Re: On-Going Services
Austin Colony Phase 1B Subdivision Improvement Plans – 1st Submittal Review
Angleton, Texas
HDR Job No. 10420700

HDR Engineering, Inc. (HDR) has reviewed the plans for the above referenced subdivision and offers the following comments:

DRAINAGE MAP
PROJECT NO. 16182

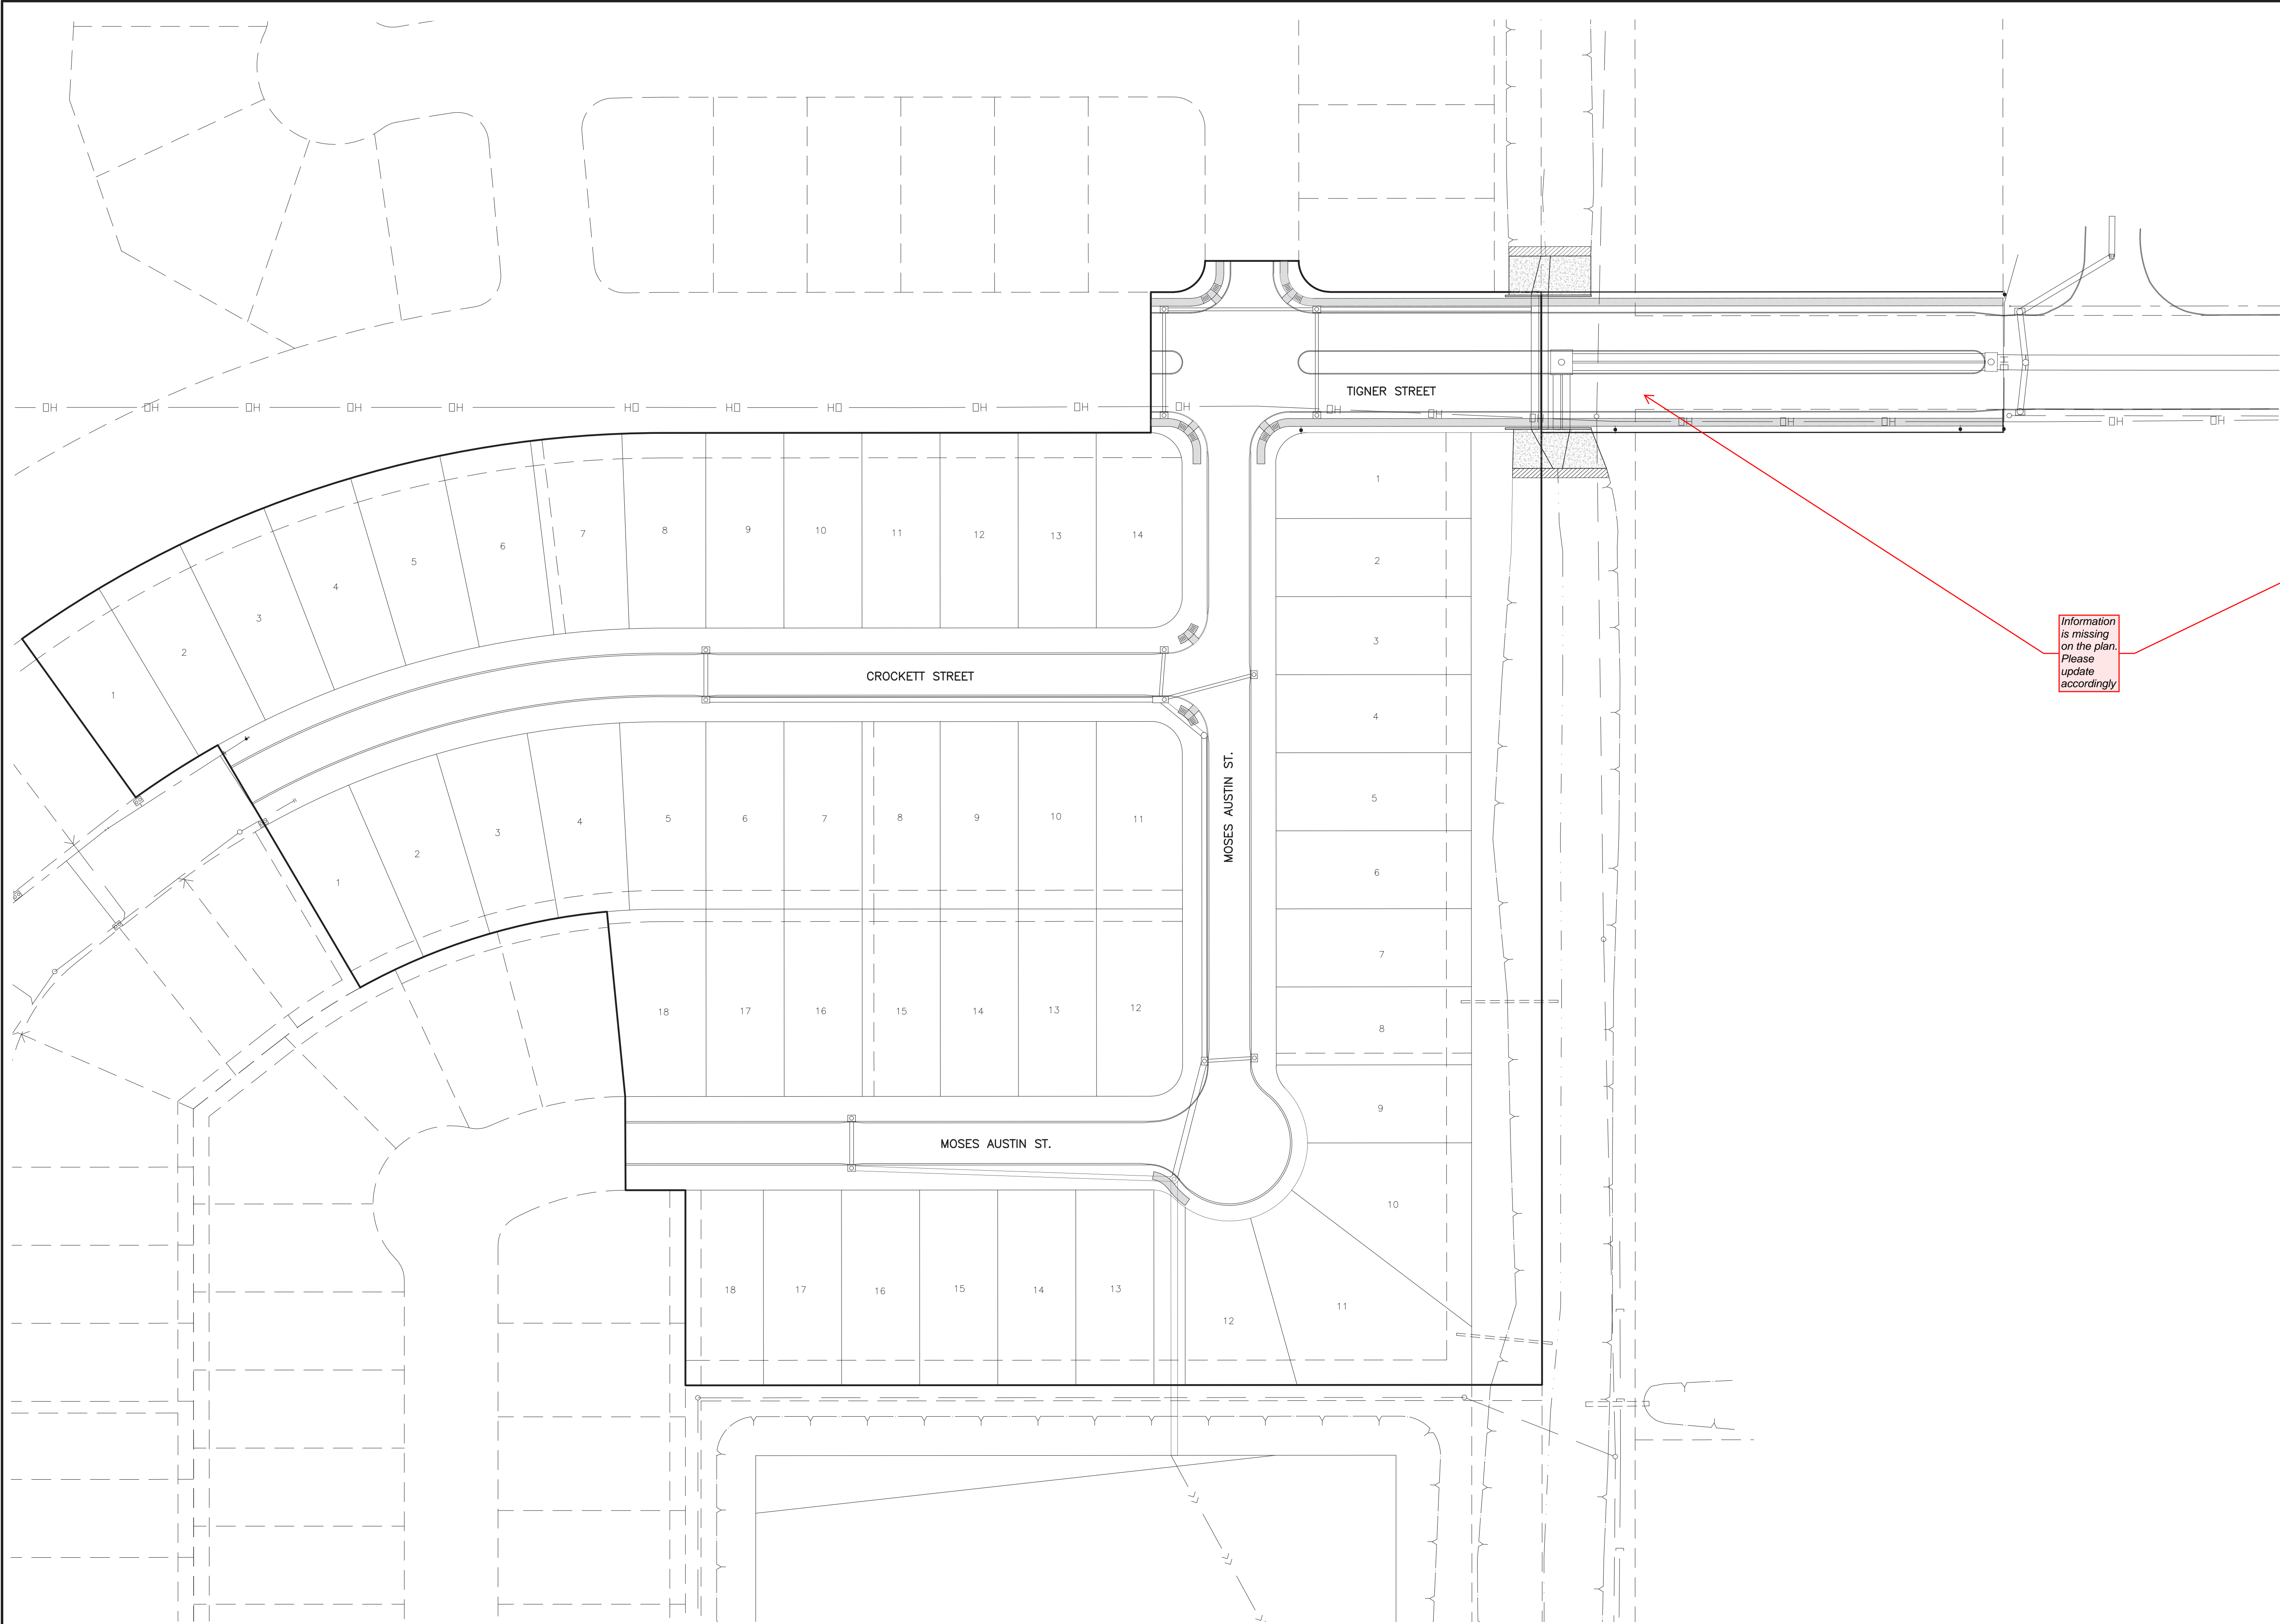
6. Sheet 7 of 50 - Label existing utilities and sizes
7. Sheet 8 of 50 - Please include the cross sections for the proposed pond as noted
8. Sheet 9 of 50 - Are these wall penetrations feasible at the inlets noted (I-10, I-5)

9. Sheet 9 of 50 - Recommend updating to provide an alignment to avoid traversing pipe in the ROW.
10. Sheet 11 of 50 - Information is missing on the plan. Please update accordingly

PLAN & PROFILE
TIGNER STREET
STA. 5+00 TO 5+60
PROJECT NO. 16182

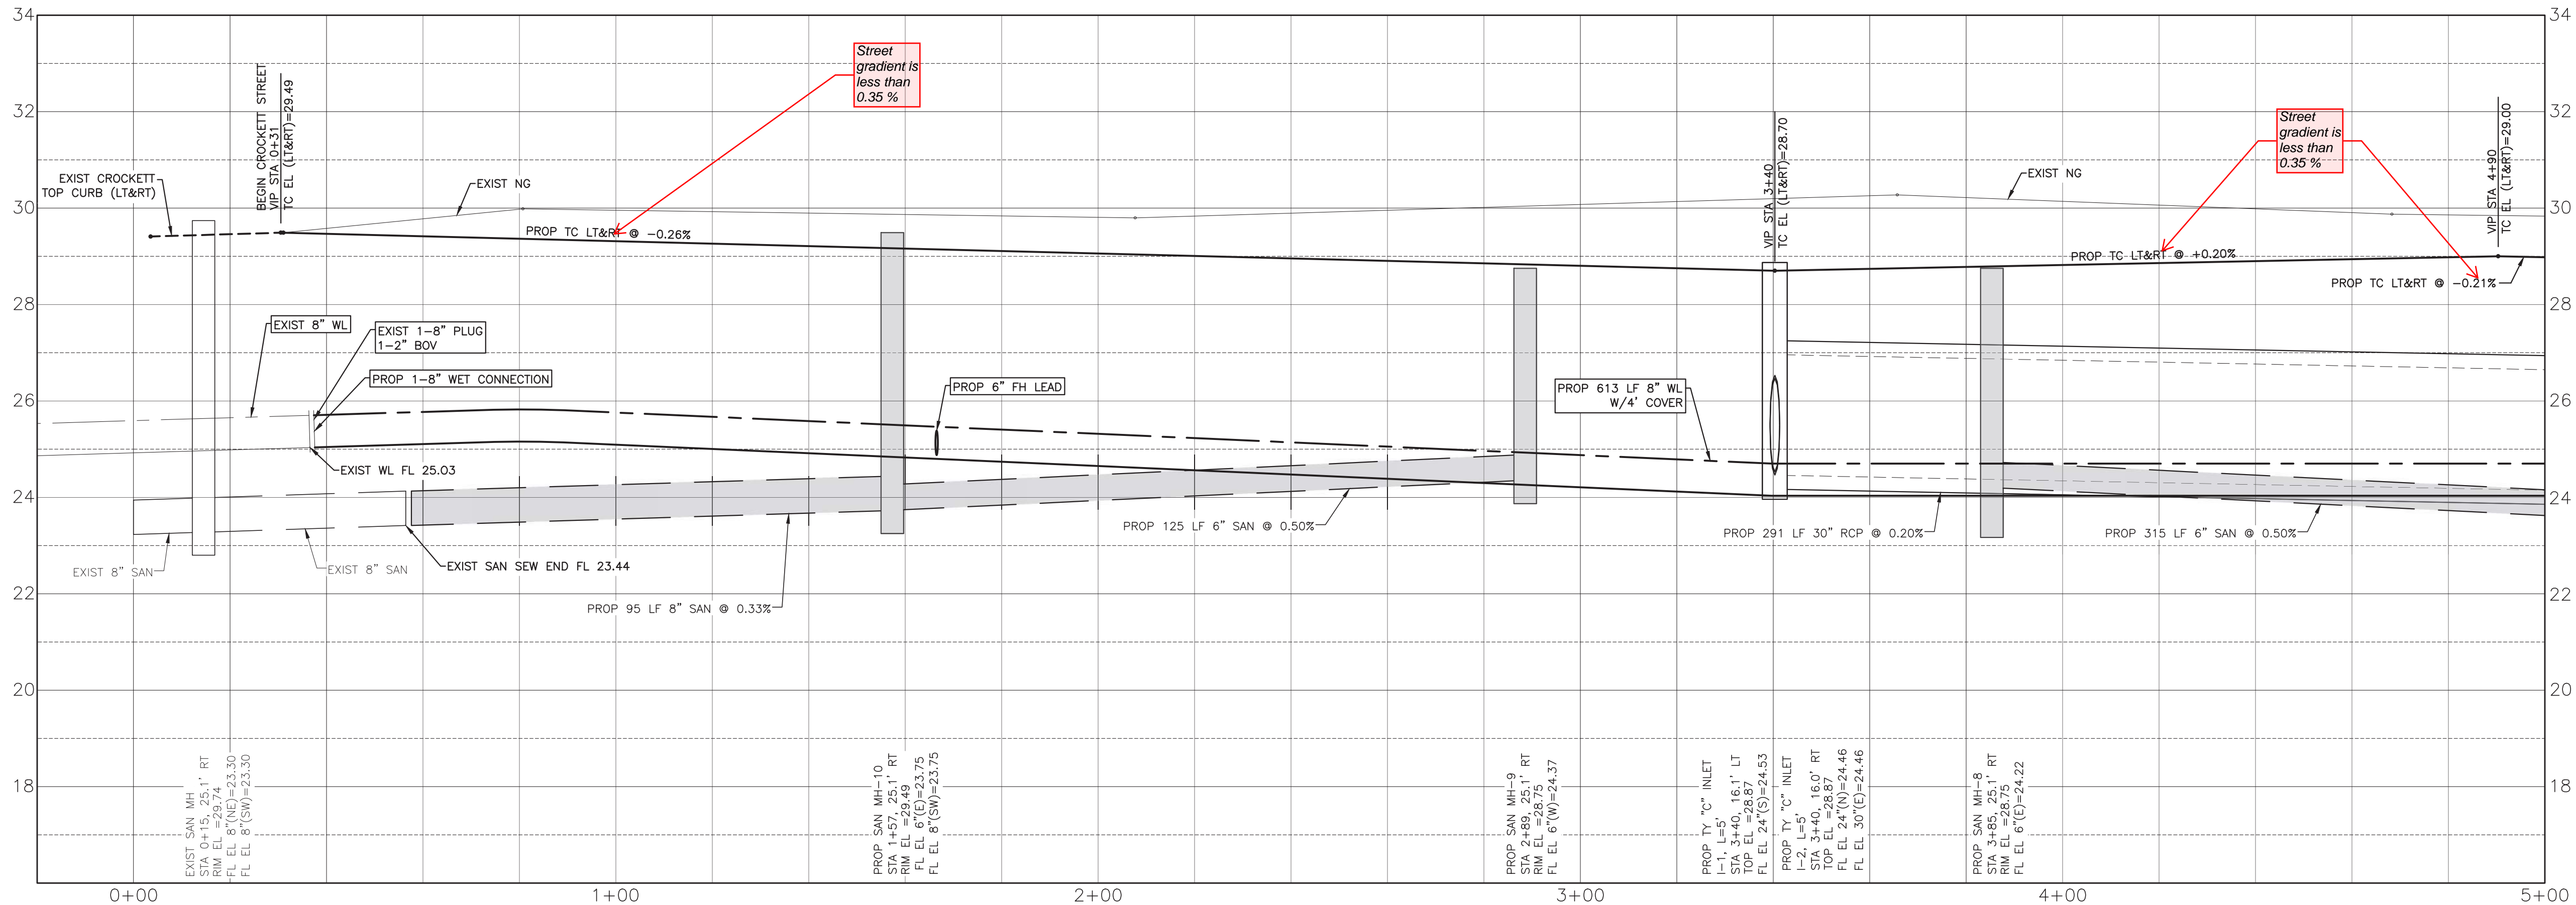
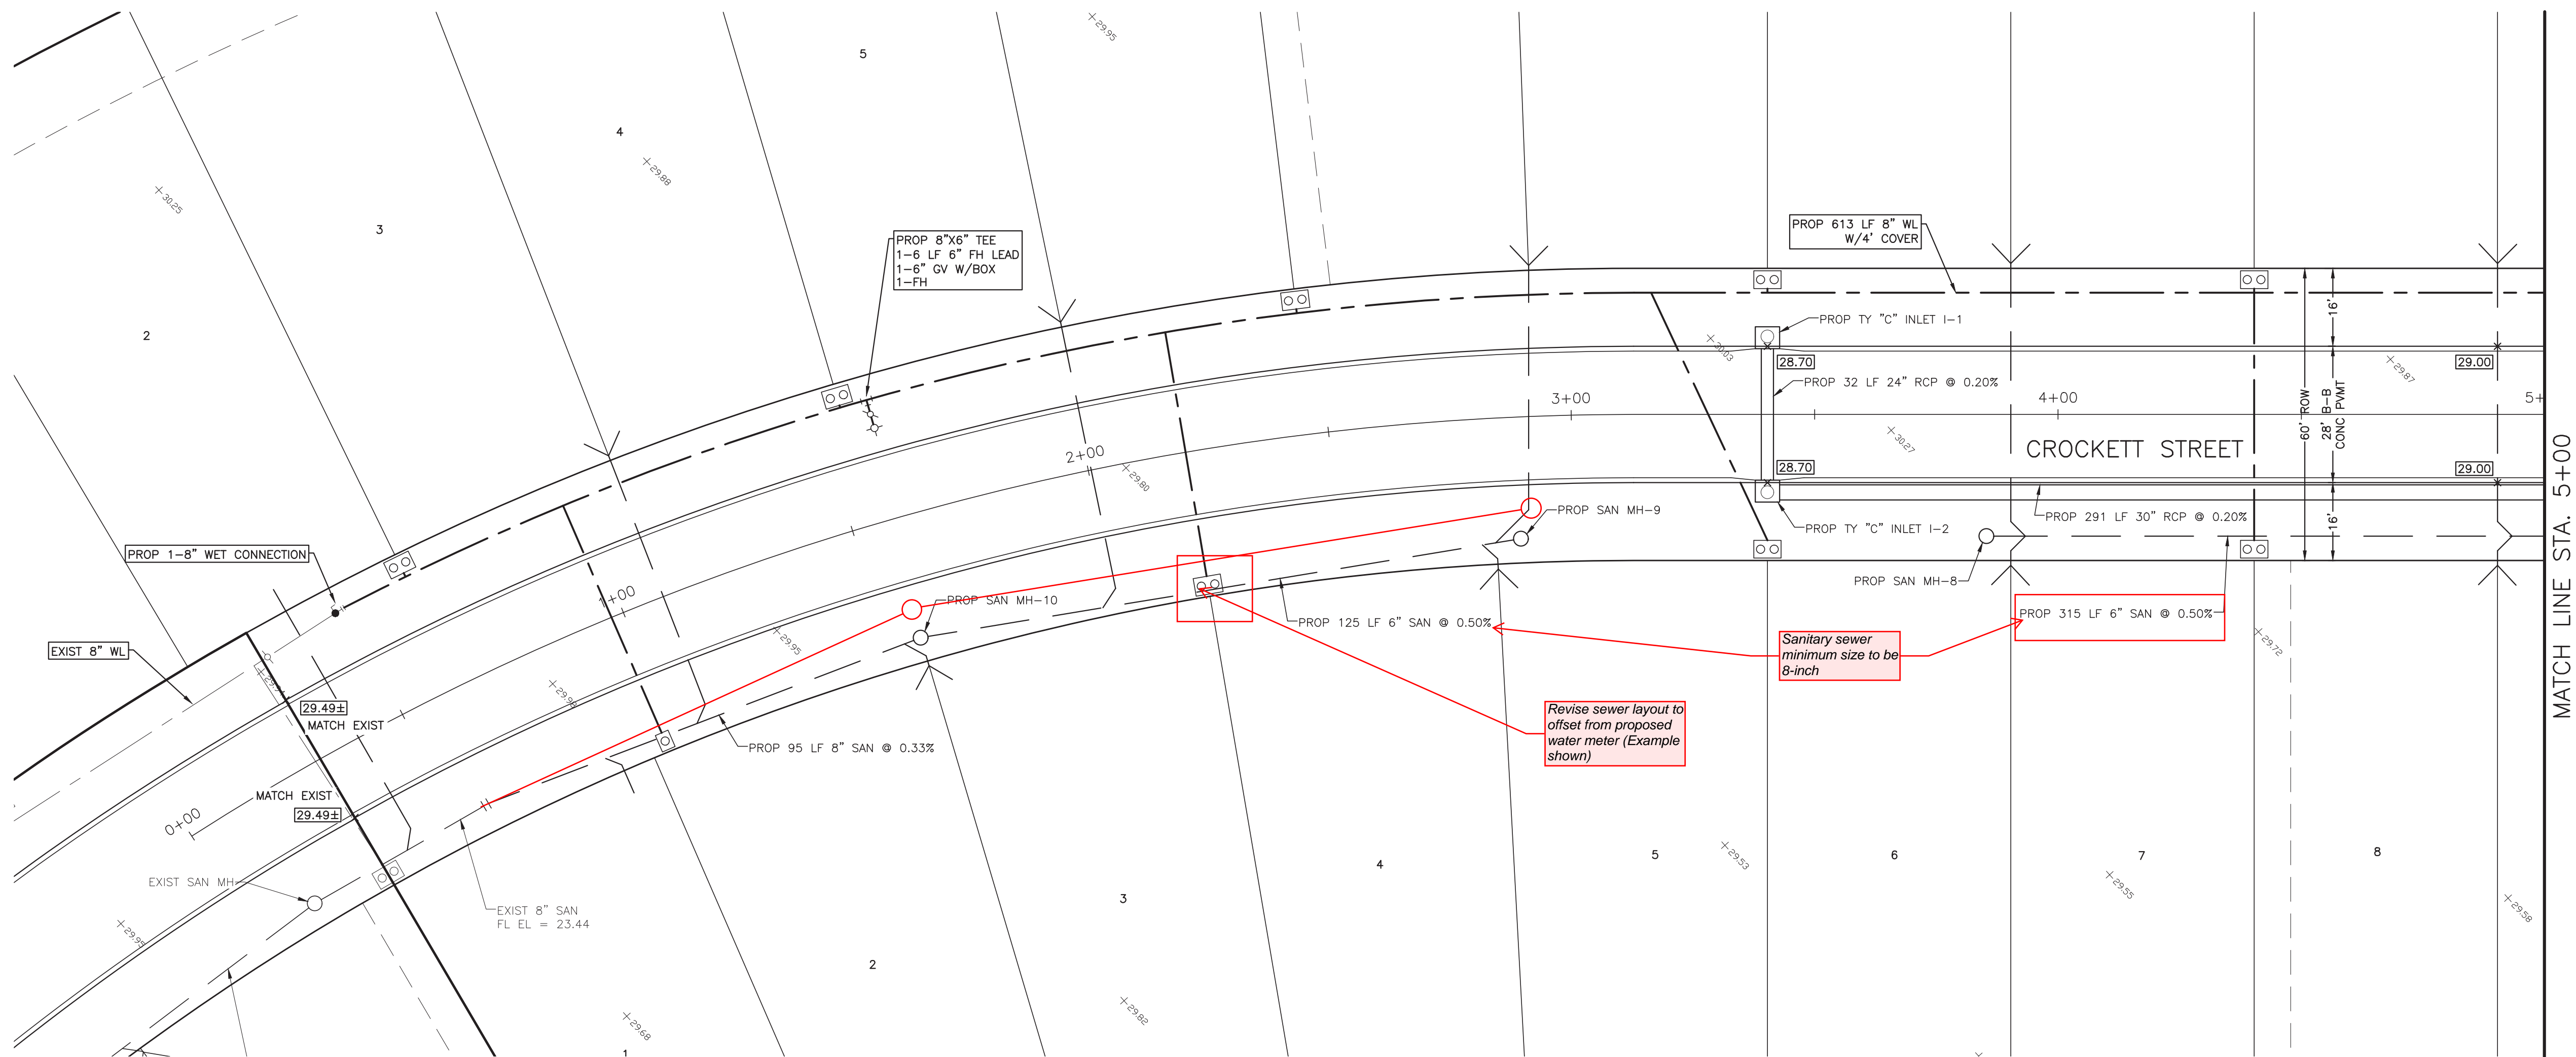
Show existing ditch highbank and flowline in plan
